**VIRGINIA ELECTRIC AND POWER COMPANY**  
**NORTH ANNA POWER STATION UNITS 1 AND 2**  
**ADDENDUM TO APPENDIX R REPORT - EXEMPTION REQUEST NO. 1**  
**PENETRATIONS IN CHARGING PUMP CUBICLE SOUTH WALL**

ADDENDUM TO EXEMPTION REQUEST # 1  
APPENDIX R REPORT  
NORTH ANNA POWER STATION

JUSTIFICATION FOR ADDENDUM  
EXEMPTION REQUEST # 1  
NORTH ANNA POWER STATION

1.3

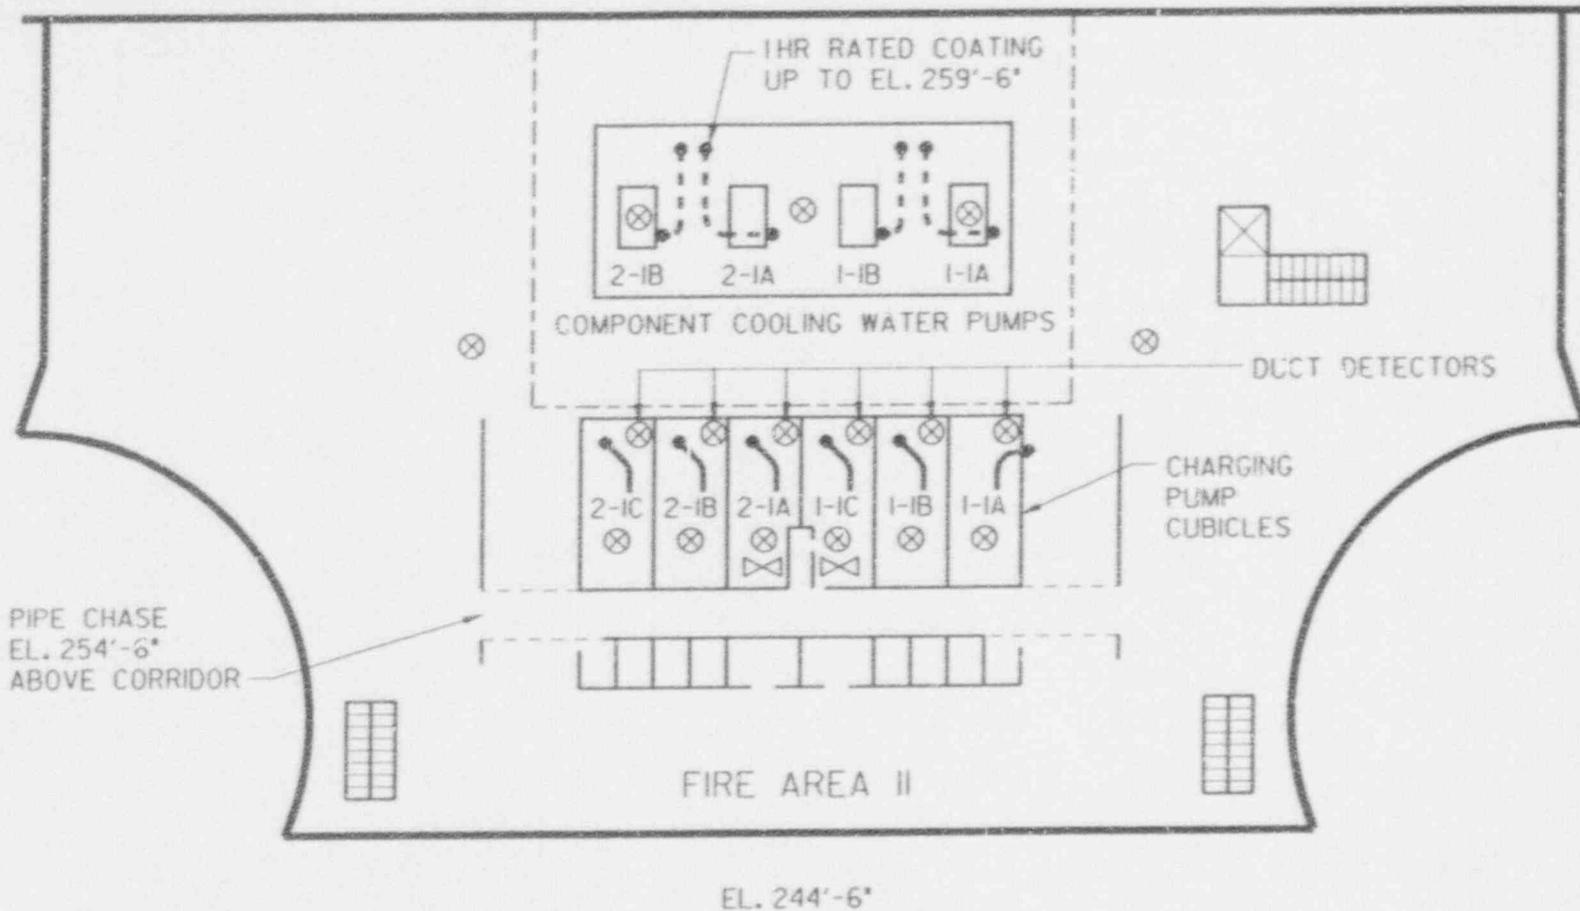
"The horizontal pipe chase is located south of the charging pump cubicles and extends along the south wall of each pump cubicle (See Figure 1.3). The pipe chase is open ended at the pipe penetration areas adjacent to the

2. Figure 1-3 is replaced with the revised Figure 1-3 (attached).
